Ref: **NEW RIVER C & TC – GHENT ATC RENOVATION RFB 26244**

Subj.: ADDENDUM BULLETIN NO. 6

ATC RENOVATION
NEW RIVER COMMUNITY & TECHNICAL COLLEGE
527 Odd Rd.
Ghent, WV 25843

E-2.1r

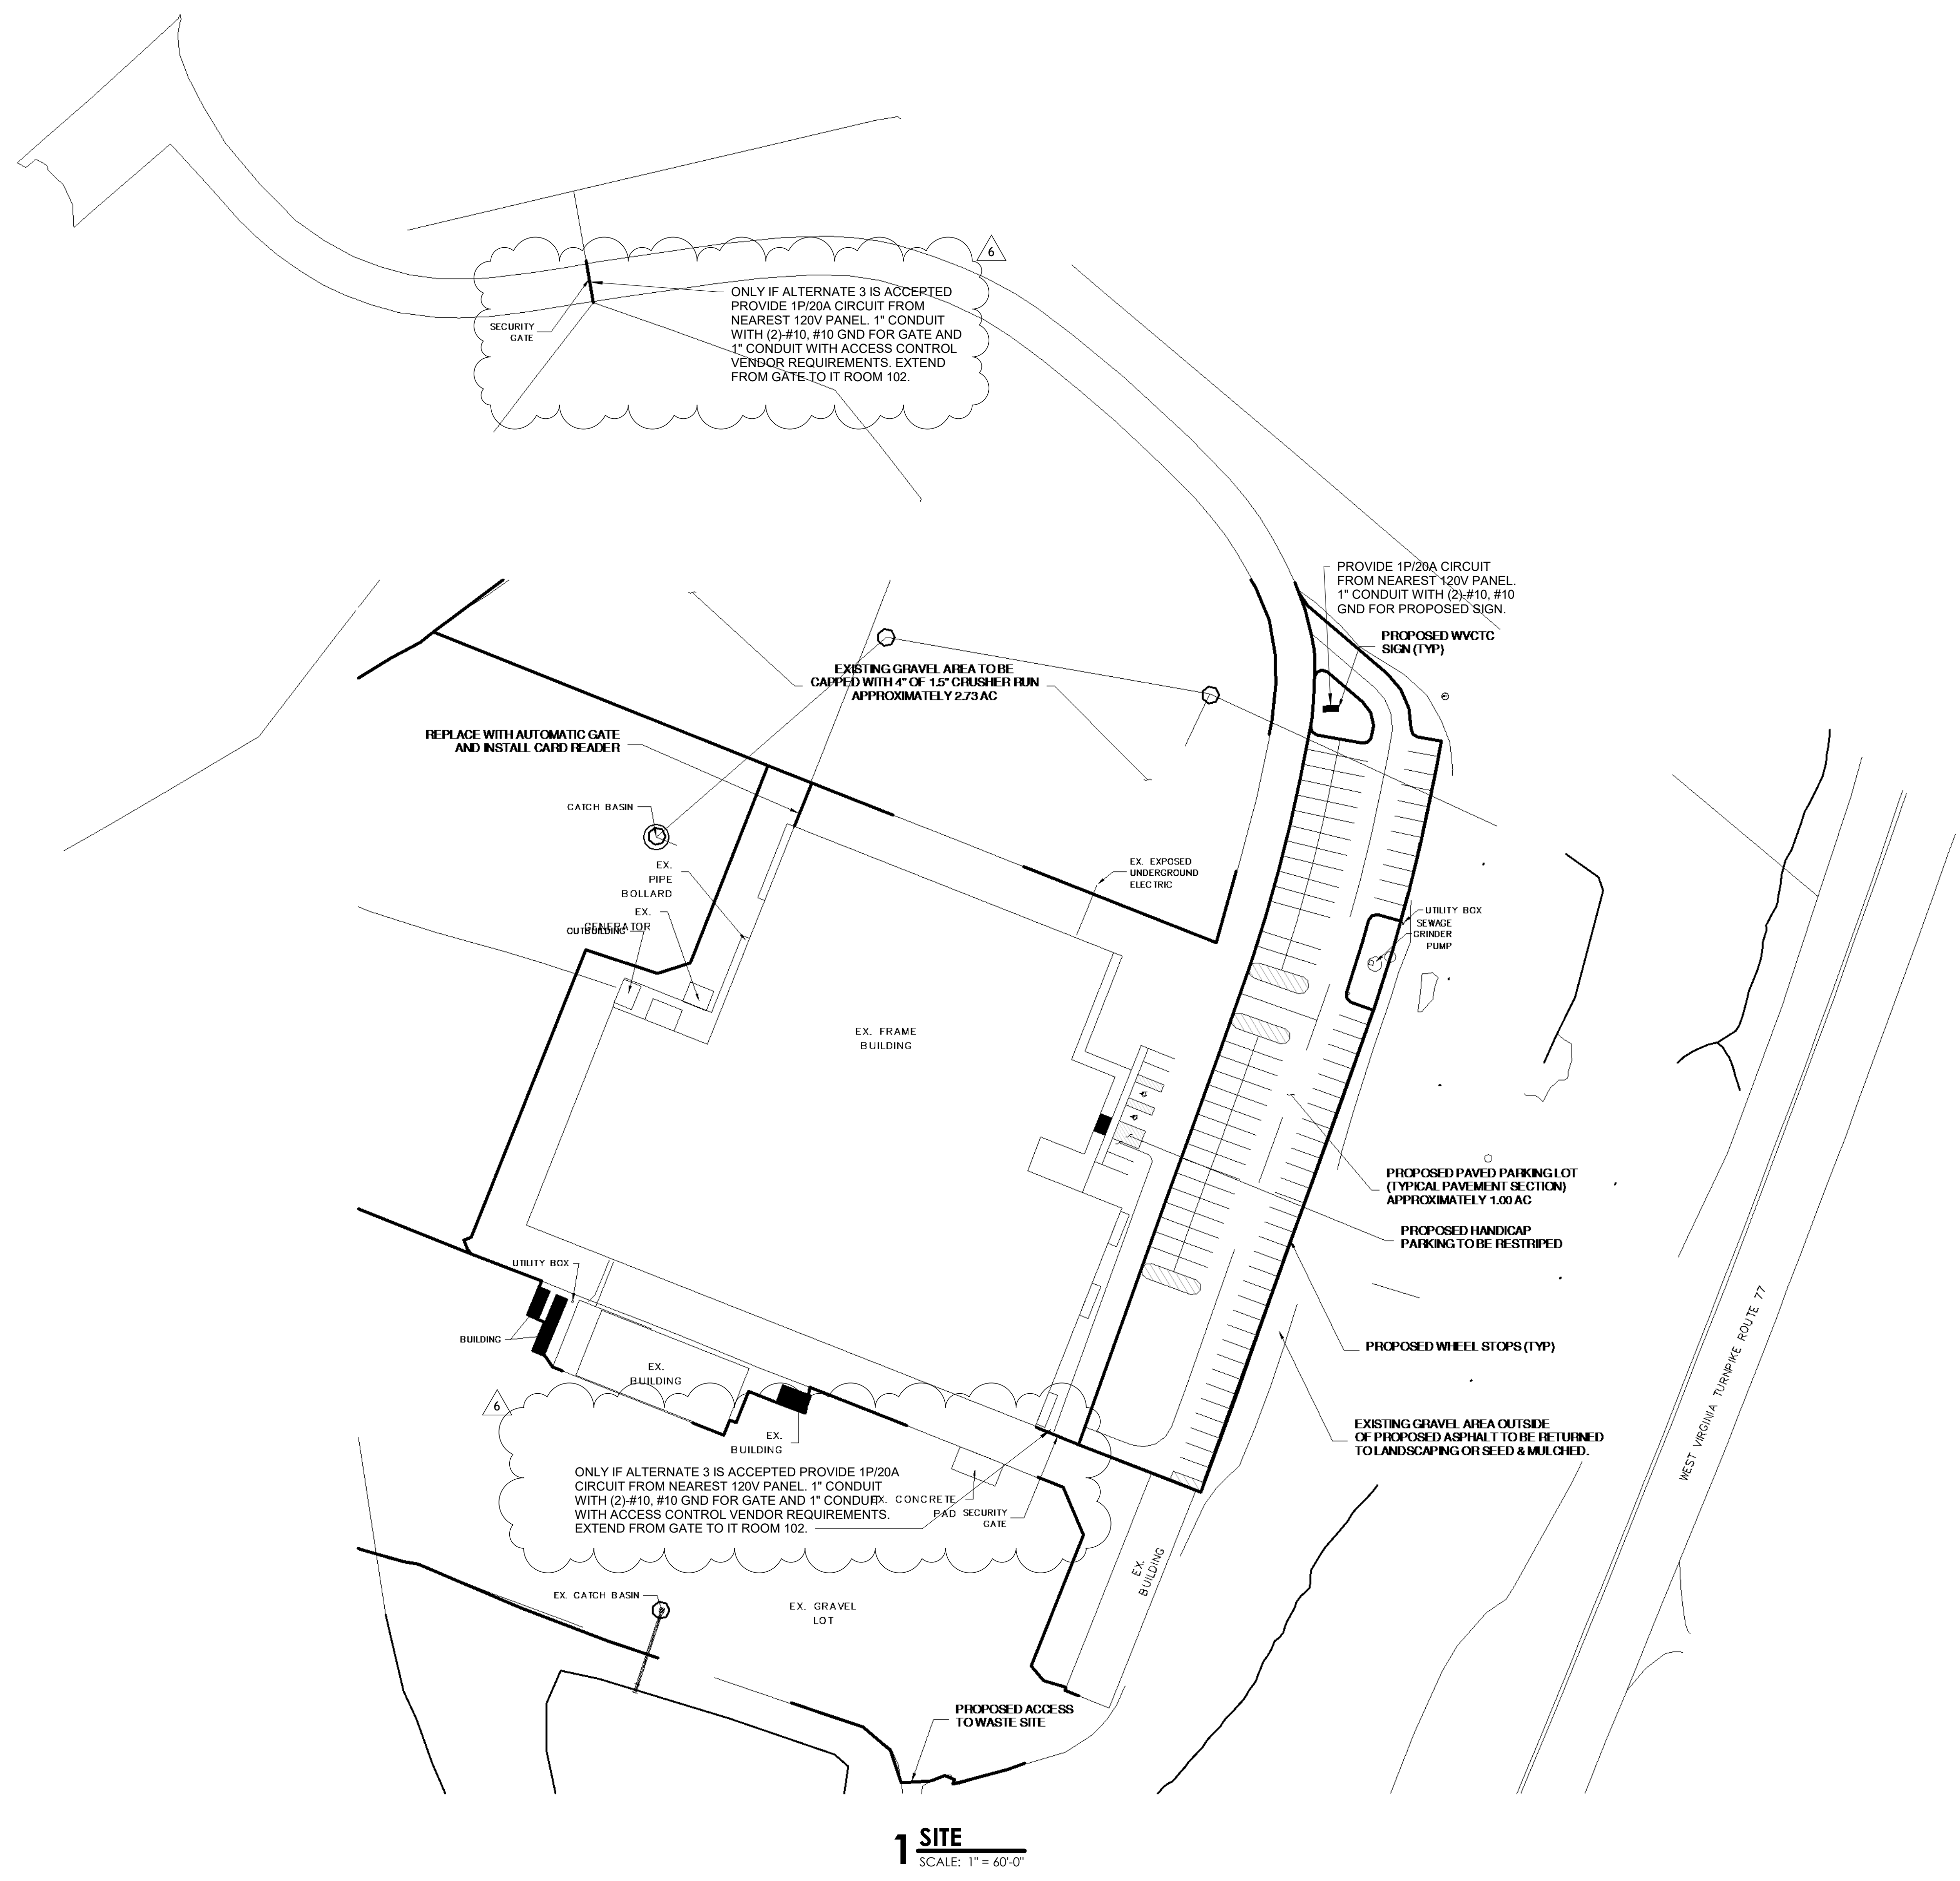
<p>Drawings state to replace and match slide gate with operators. What type of fence and how tall are the gate openings?</p>	<p>Contractors to verify fencing prior to bid submission.</p>	<p>4</p>
<p>3.What are the fiber requirements for the gate mentioned on sheet E2.01?</p>	<p>See updated E-2.1r in Enclosures.</p>	<p>4</p>
<p>2.Where is the data rack that the cameras and security doors are being fed from? A drawing with the location would be preferable.</p>	<p>Main data rack to be placed in IT Room 102.</p>	<p>4</p>

Section 083323 2.3, C., 6 Please provide specs for the Commercial Light Package	No new lighting package in relation to Insulated Rolling doors. Section can be removed from specification.	6
Section 083323 2.3, C., 3: Card readers are typically provided by the contractor supplying the alarm system. Are they required by the overhead door contractor?	No card reader for Overhead motorized doors.	6
Section 083323 2.3, C., 1 Is vehicle detector operation required? If so please provide specs	No vehicle detector required at Insulated Rolling doors. Section can be removed from specification.	6
What headend requirement will be needed for the security cameras in the existing IT room? Is there an existing patch panel for the cables to be terminated on?	I would assume there is not an existing patch panel. Contractor to field verify.	6
According to Addendum #4, there is no longer a fiber requirement for the security gates. Will there be a need for conduit to be run for some type of control cable, and if so, where will the control cable be ran from?	1" conduit with access control vendor requirements. extend from gate to IT room 102. Refer to sheet E-2.1r for continuation.	6
